Robin Partington & Partners
built around people

Non-material Amendment April 2016

Parker House Addendum Statement

This report sets out a number of technical issues identified within the consented Parker House scheme, and the proposed responses and design solutions that together form this NMA application. This follows a Pre-Application meeting with Camden Council which was held on 23rd March 2016, and attended by planning and design officers. It was agreed that the revisions were non-material in principle, subject to adequate technical and design justification.

CONSENTED GROUND FLOOR PLAN

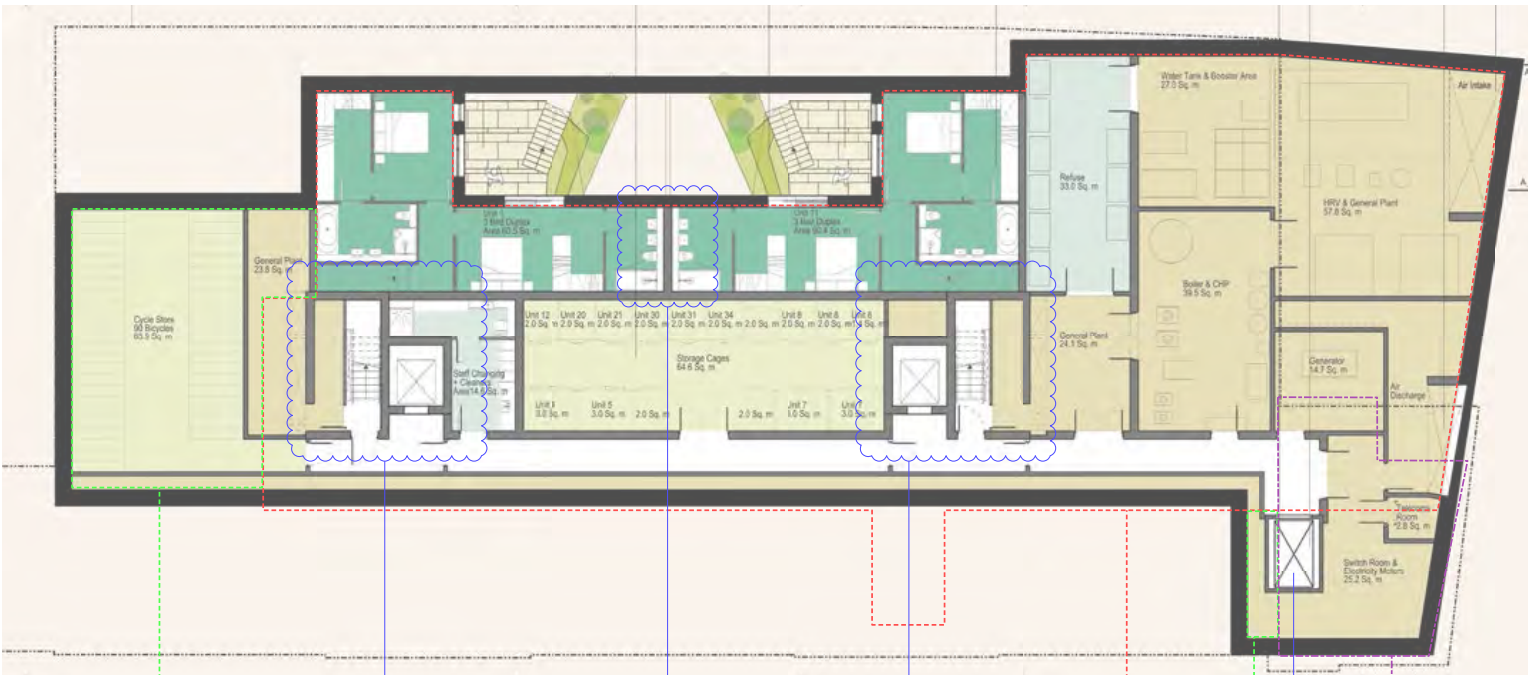
- Following an in depth analysis of the MEP strategy of the consented scheme, it was concluded by the client's MEP Engineer, Scotch Partners, that the plant area allowance had been underestimated.
- In order to maintain the consented ceiling height of the basement, and avoid any further excavation, a strategy has been devised to accommodate the required plant and associated ductwork within a revised layout.
- The proposal incorporates an existing basement area which had not been included in the consented scheme.
- As a result, an increase in floor area of 38sqm is required, which represents a 6% increase of the consented floor area.
- The revised basement layout has been reviewed and agreed by the client's structural engineer, AKT II.

- Consented basement 635.5 sqm (not including existing basement)
- 6% increase 38.1 sqm
- Reutilised existing basement 32.4 sqm
- Proposed basement = consented + 6% increase + existing = 706 sqm

CONSENTED SCHEME - TYPICAL LAYOUT, WEST CORE

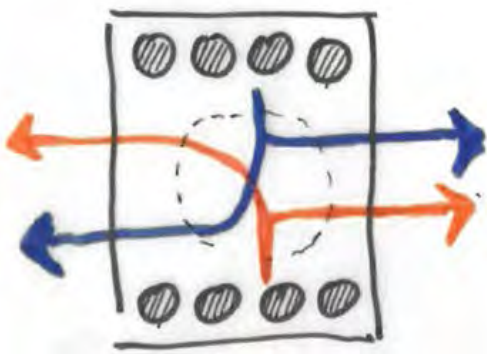
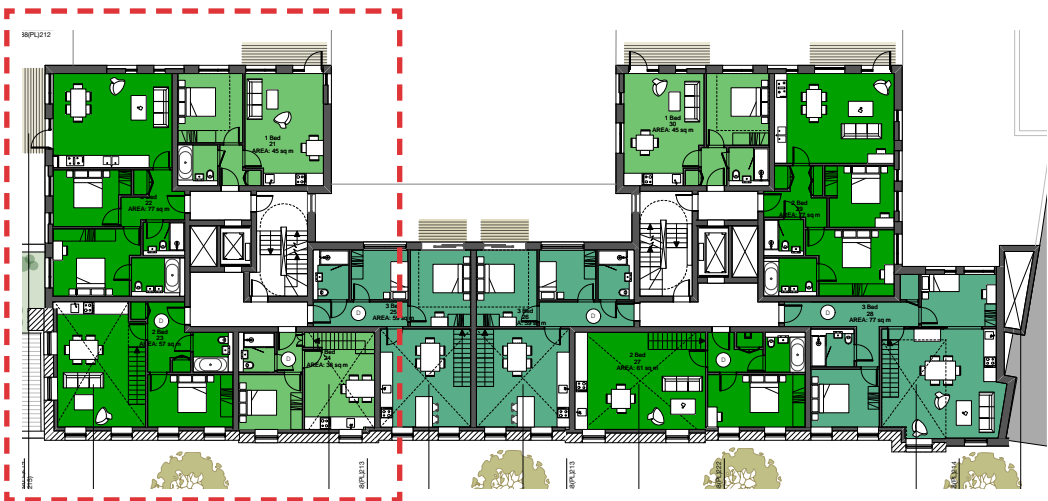
- Due to the shape of the risers throughout the building, much of the riser area is 'unusable' as it cannot be accessed from the landings.
- The additional riser area required must therefore be located elsewhere. As demonstrated in the diagram above, wherever this area is located, it has a major impact upon the layouts of the apartments, in many cases to the extent that they are no longer viable.

CROSS SECTION - CONSENTED SCHEME

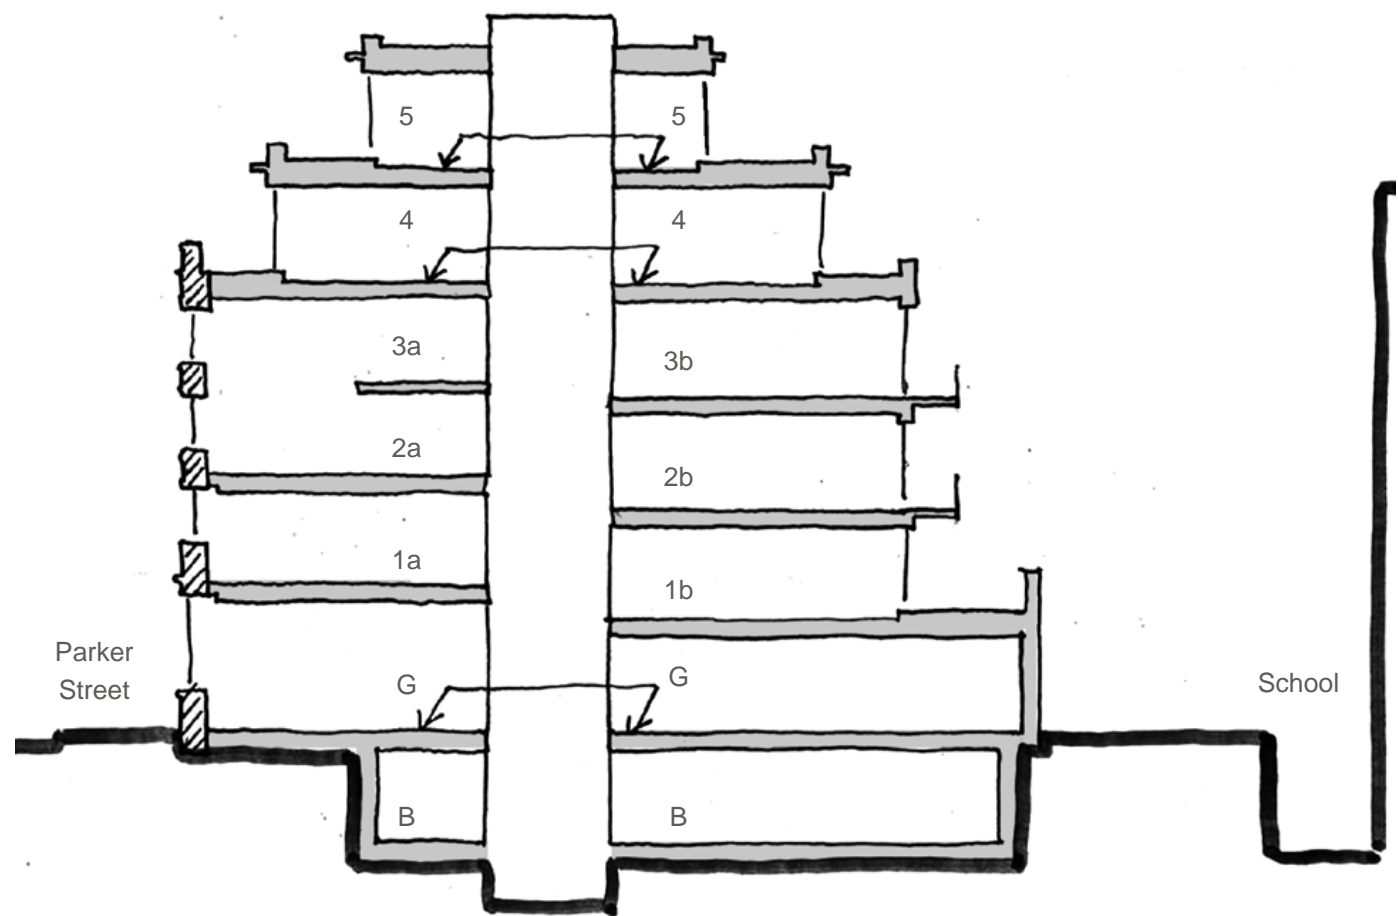
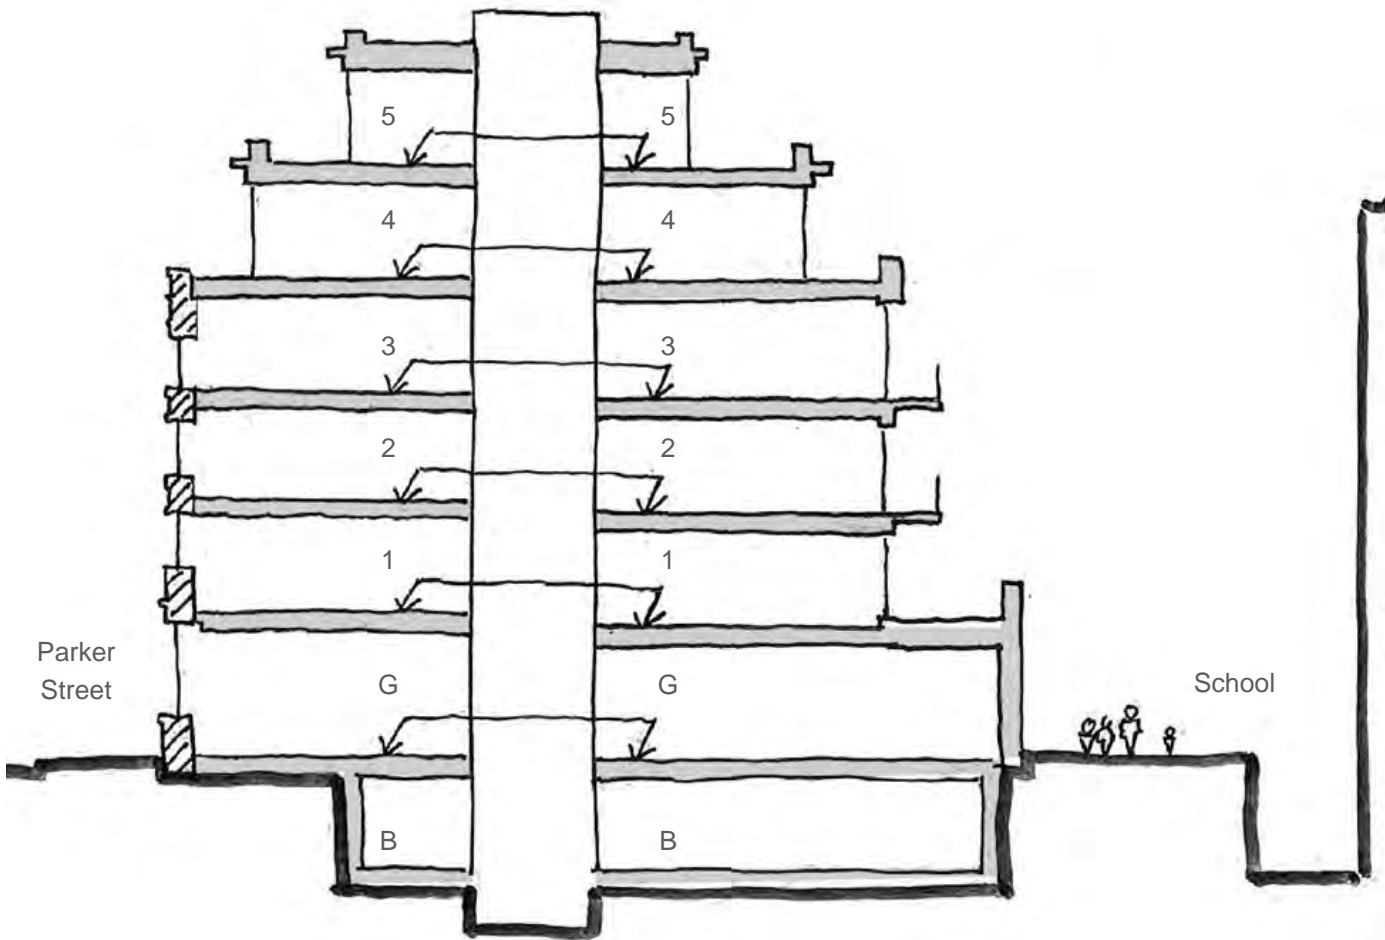
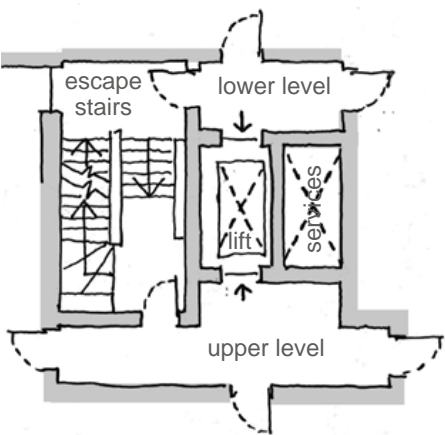
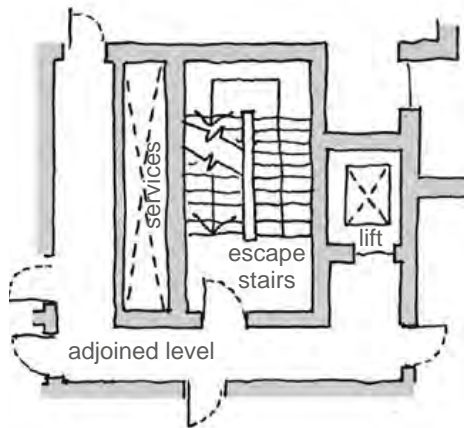
- A key feature of the consented scheme is that there is a difference in the levels between the front of the building and the rear of the building. This means that there is a significant 'doubling up' of services, to serve both corridors either side of the core.
- As the services are located in the ceiling of the corridor, the more services there are, the less height is available for general circulation.

- Adjoining the split levels allows the following:
 - A more efficient shape to the riser, accommodating all of the services, and therefore not impacting on the layouts of the apartments.
 - A lesser amount of services required in the ceiling of the corridor, therefore not compromising the circulation.

DETAIL A - TYPICAL FLOOR BUILD UP

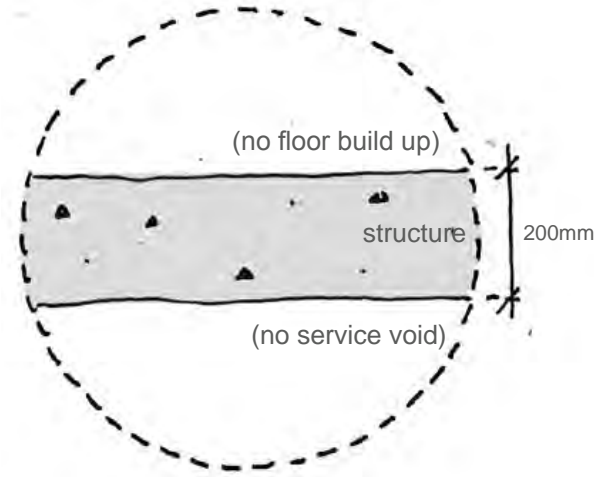
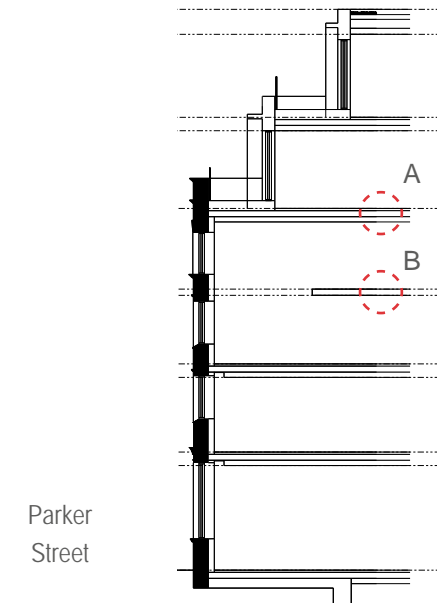
- Within the consented scheme, the typical floor build up is within a 450mm zone, and the duplex floor build up is within a 200mm zone.
- There is a consistent 200mm thick structural slab, with no allowance for deflections.
- Typically, there is a service void of 175mm, to accommodate all services and the dropped ceiling fixing system.
- There has been no allowance for a service void within the duplex apartments.

PROPOSED SCHEME -
CROSS SECTION

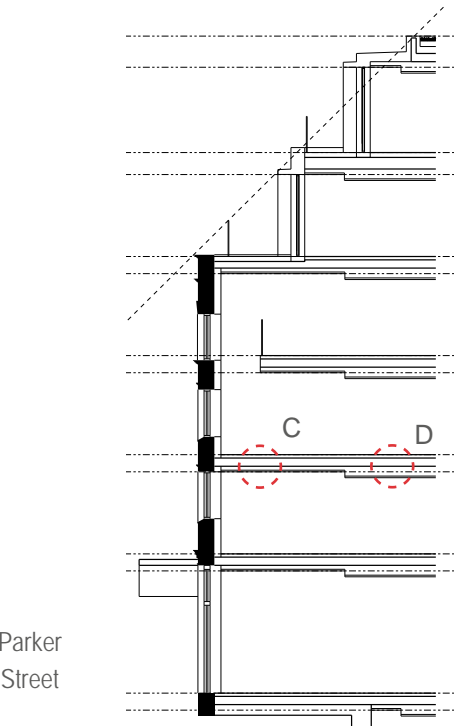
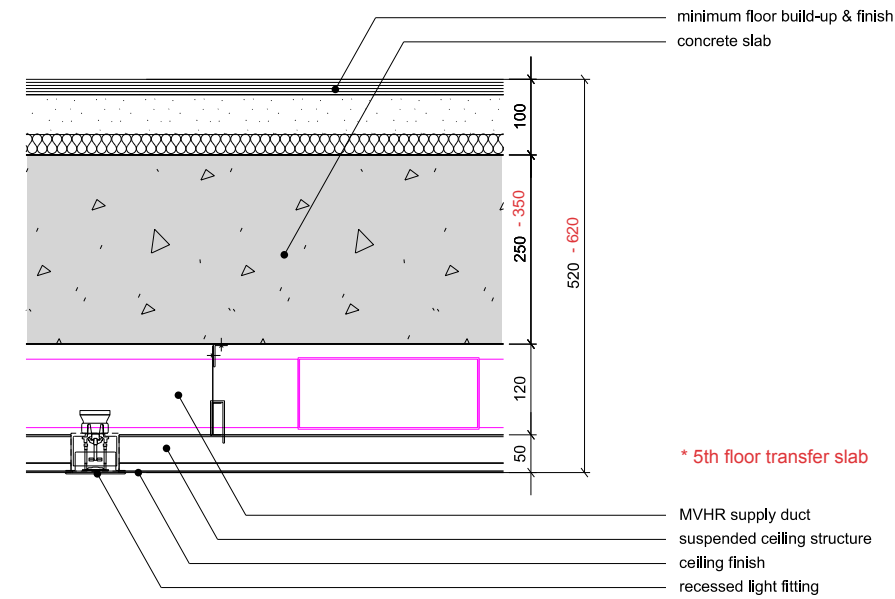
- Details C and D demonstrate the two conditions for proposed ceiling voids, following detailed consultation with MEP consultants.

- Detail C - Ceiling void reduced to minimum in Living Room and Bedrooms:

Below the 250mm slab, a minimum 120mm zone is required for ductwork. In this condition, there can not be any crossing over of services. A suspended ceiling system, plus a plasterboard finish requires a zone of 50mm.

- Detail D - Ceiling void reduced to the minimum for cross overs in Bathrooms, Kitchens and Lobbies:

Below the 250mm slab, a minimum 300mm zone is required for services. This conditions is applied when the crossing over of ductwork is unavoidable. A suspended ceiling system, plus a plasterboard finish requires a zone of 50mm.

- A transfer slab of 350mm is required at fifth floor.

Section Facing Parker Street

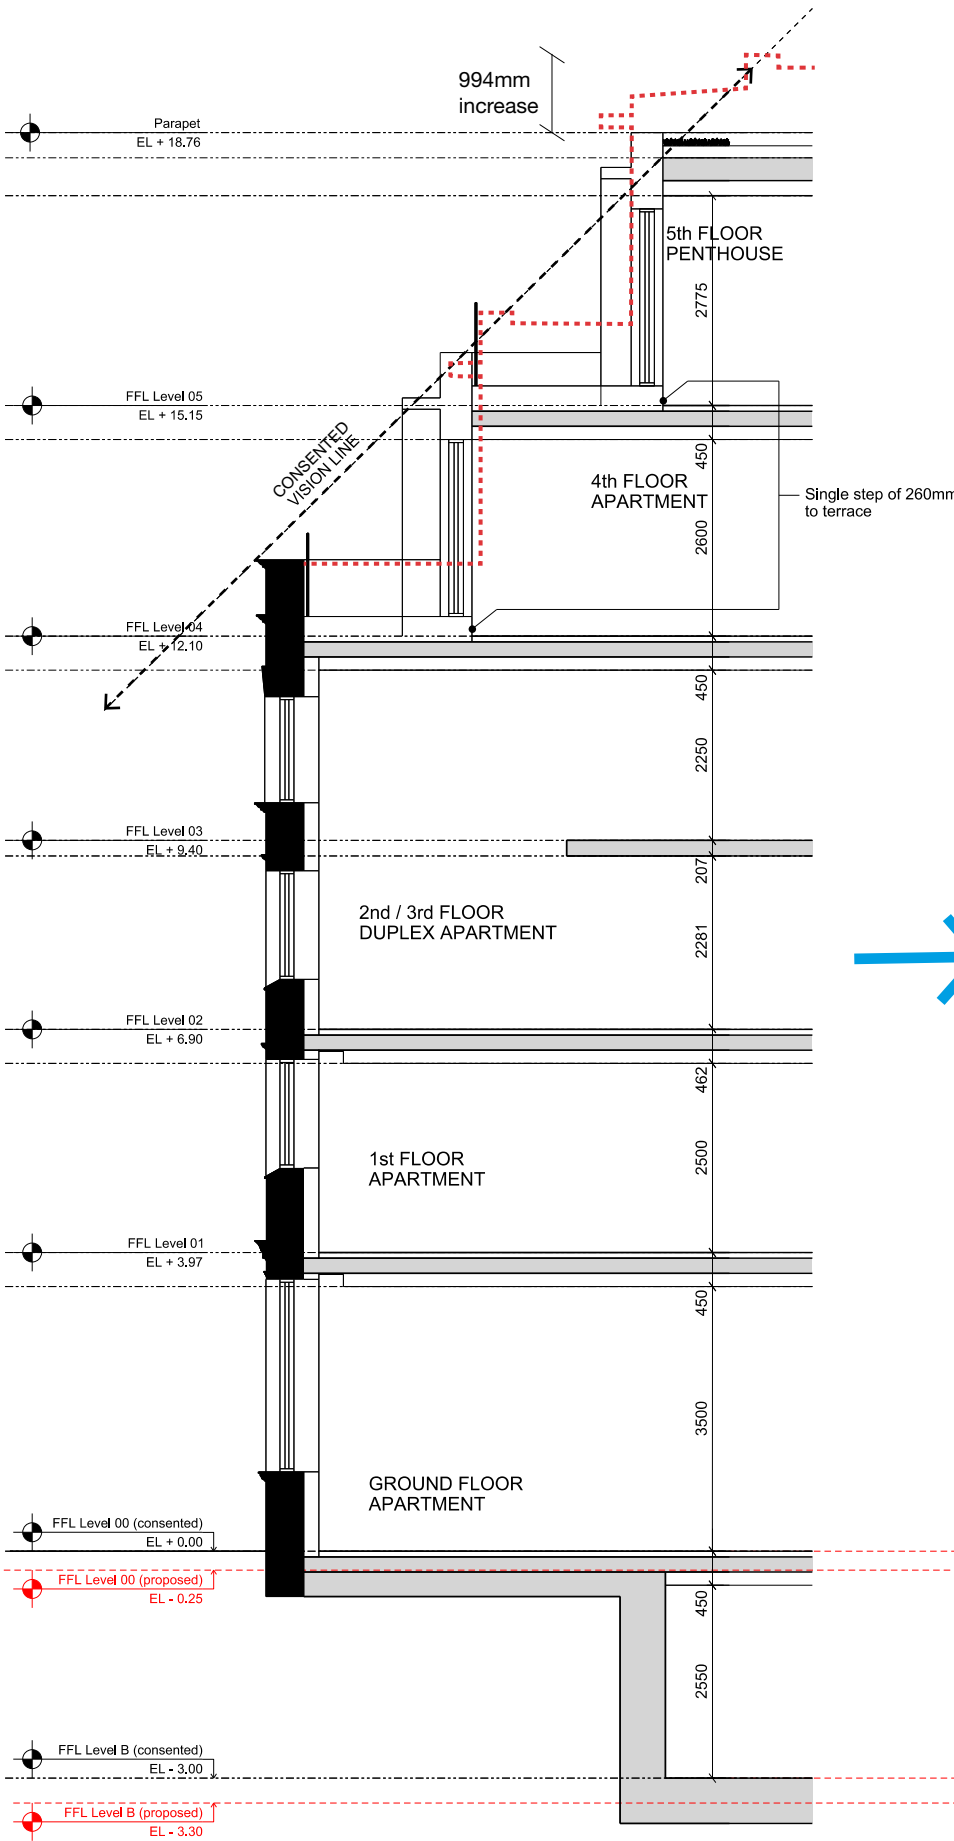
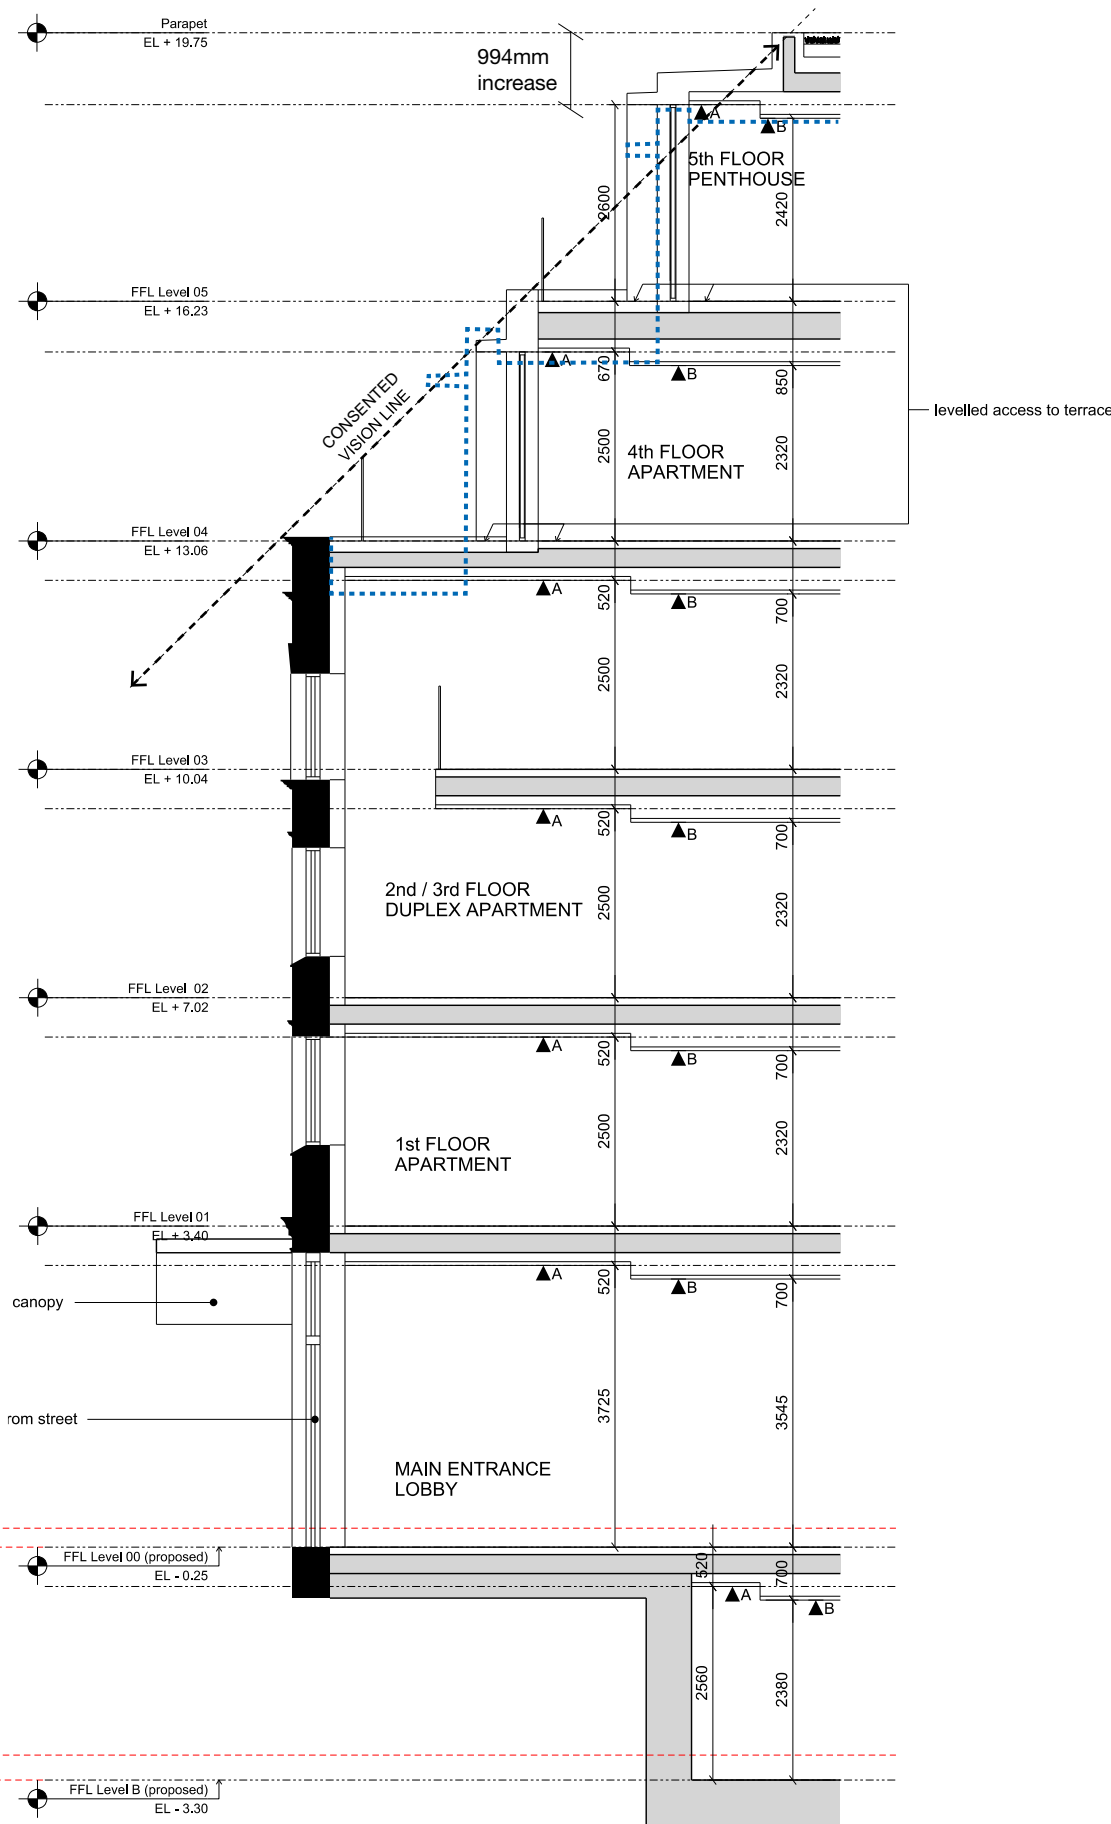
- Consented section on left hand side demonstrates the floor build ups and ceiling heights within the approved scheme.
- As demonstrated on page 10, floor build ups have been undersized and do not meet minimum requirements. Once minimum floor build ups are considered, ceiling heights are further compromised.
- Proposed section on right hand side demonstrates result of considering minimum floor build ups, and consistent ceiling heights of 2320mm-2500mm (depending on ceiling void condition) across floors 1-4, and 2420mm-2600mm in Penthouse.
- Proposed ceiling heights do not exceed consented ceiling heights (other than those that were described as 'compromised'), and remain acceptable and compliant with relevant design guidance.
- Profile of roof parapet has been revised so as not to impact on Parker Street. This includes stepping back the roof parapet, and reducing the depth of the canopy.
